Department of Public Works **Memorandum**

Date: March 12, 2026

Subject: **Community Center Parking/Crosswalk Improvements**

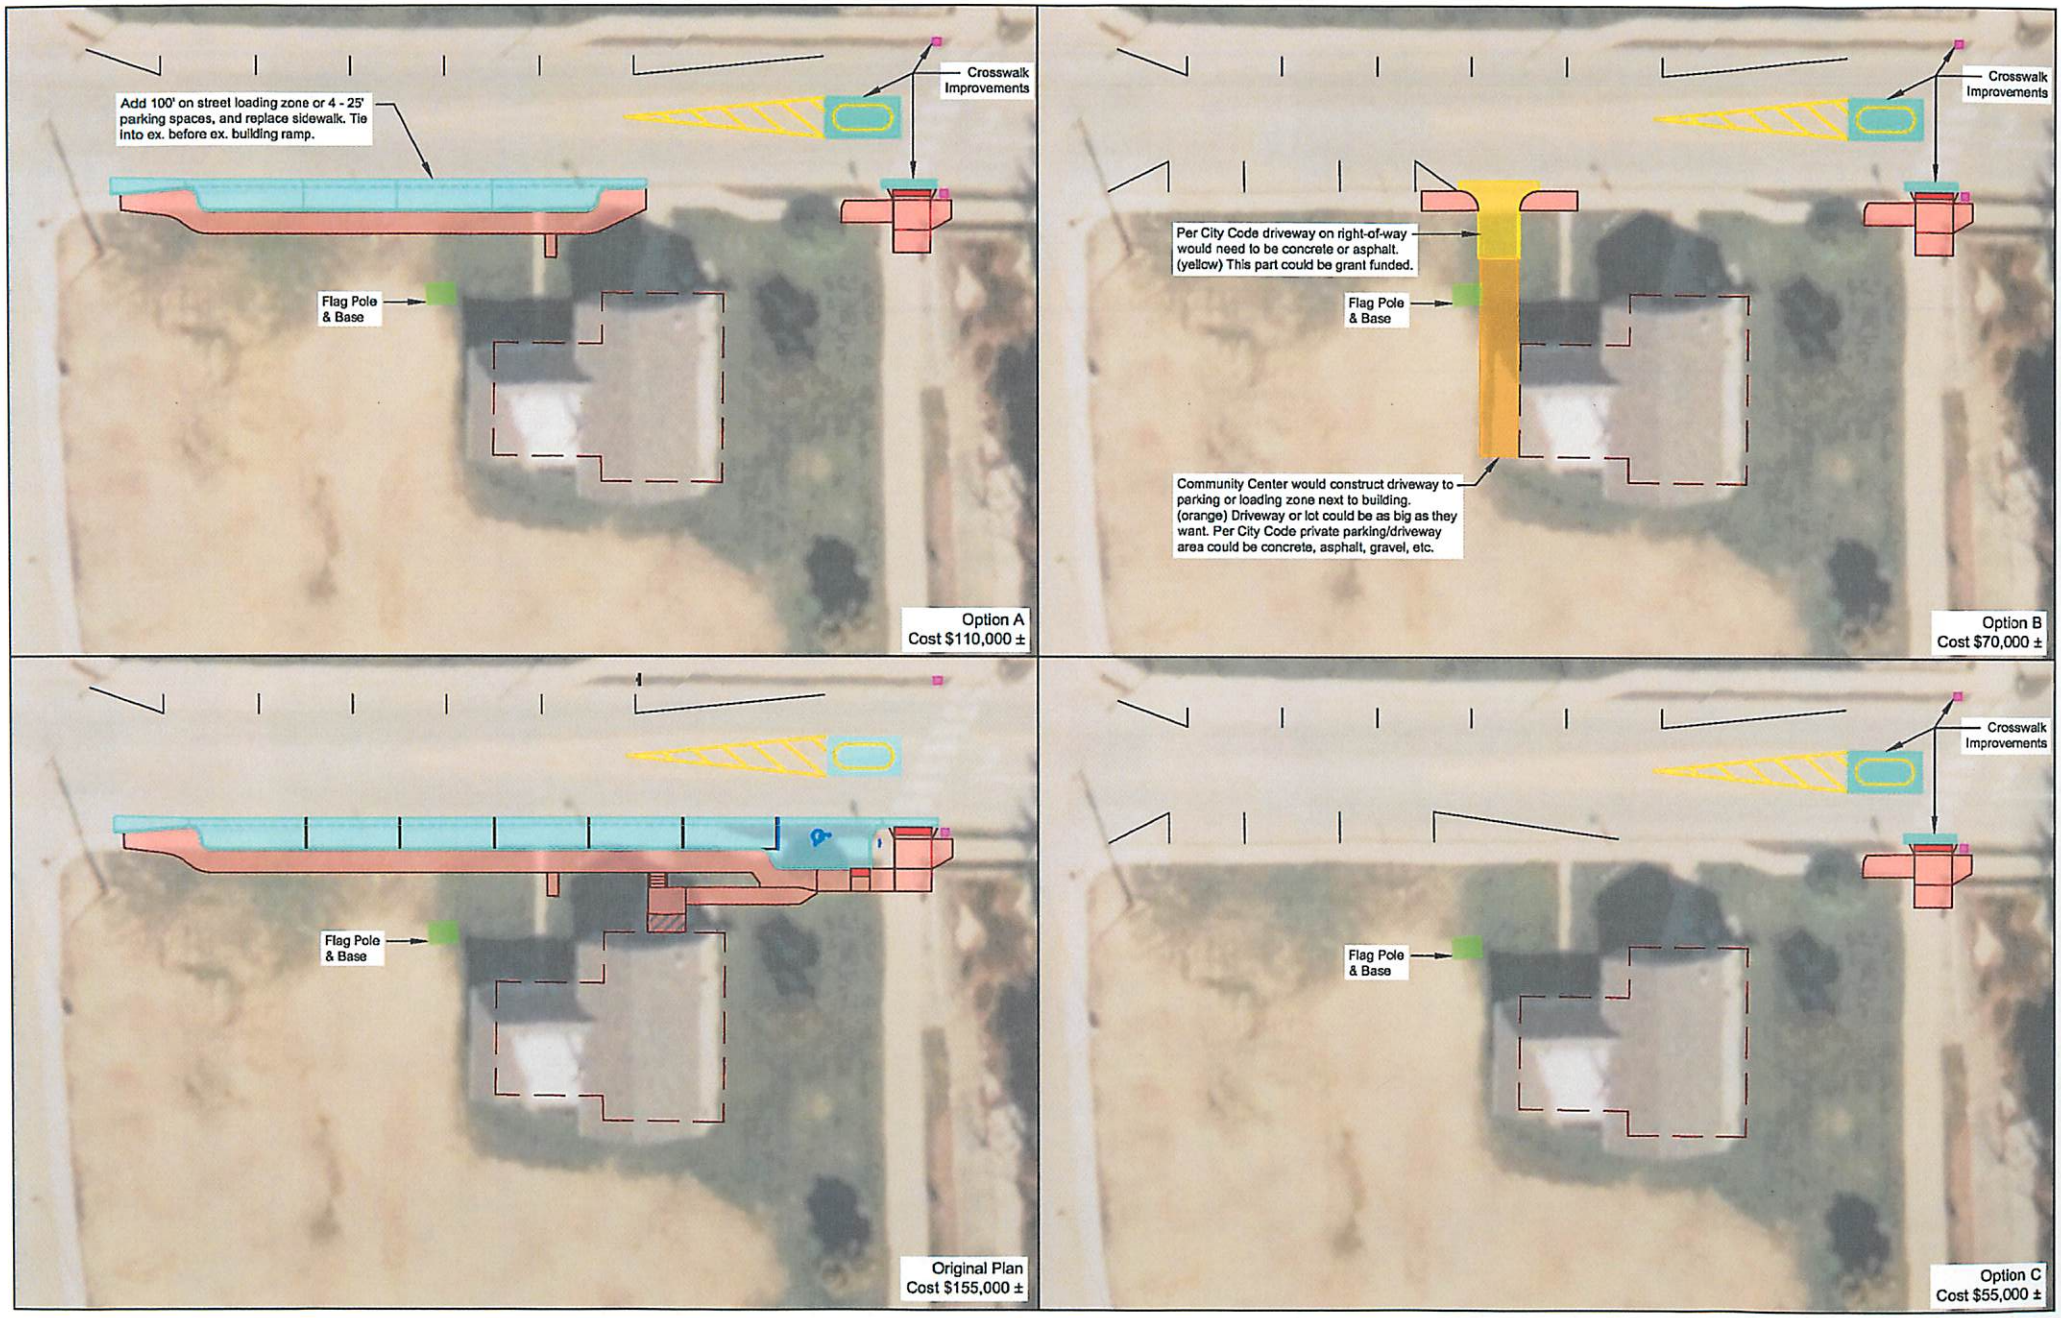
These three options shown on the attachment present a reduction in scope and cost as compared to the original design while all maintain the same crosswalk improvements.

Option A is the most similar to the original design and creates four parking spaces that are moved outside the travel way. This reduction in added spaces, including the ADA accessible space, reduces the added costs associated with the sidewalk ramps to the building and the retaining wall that were part of the original plan. This option moves cars away from the travel lane allowing greater access to enter and exit the vehicle and allows for better sightlines to pedestrians approaching the crosswalk, however, it only adds two parking spaces.

Option B entails the construction of a driveway from Dunklin Street onto the property. As shown, it could provide parking space for two to three vehicles while adding an additional space on Dunklin Street. This option allows for direct vehicular access to the Community Center property which is something that they do not currently have. It would be possible for a parking area to be developed off of this driveway that could hold additional cars if necessary or desired. One downside to this option is that the CDBG funding being used for this project would not be able to be used for anything beyond the right-of-way line.

Option C does not make any physical changes to the curb lines but modifications to the gore striping resulting from the addition of the central island of the crosswalk allow for the addition of a parking space on Dunklin Street. This option is the least expensive and focuses on the crosswalk itself which in turn supports the use of the parking lots at the tennis courts as a option for the Community Center.

Add 100' on street loading zone or 4 - 25' parking spaces, and replace sidewalk. Tie into ex. before ex. building ramp.
Crosswalk Improvements
Flag Pole & Base
Option A
Cost $110,000 ±
Per City Code driveway on right-of-way would need to be concrete or asphalt. (yellow) This part could be grant funded.
Community Center would construct driveway to parking or loading zone next to building. (orange) Driveway or lot could be as big as they want. Per City Code private parking/driveway area could be concrete, asphalt, gravel, etc.
Option B
Cost $70,000 ±
Original Plan
Cost $155,000 ±
Option C
Cost $55,000 ±
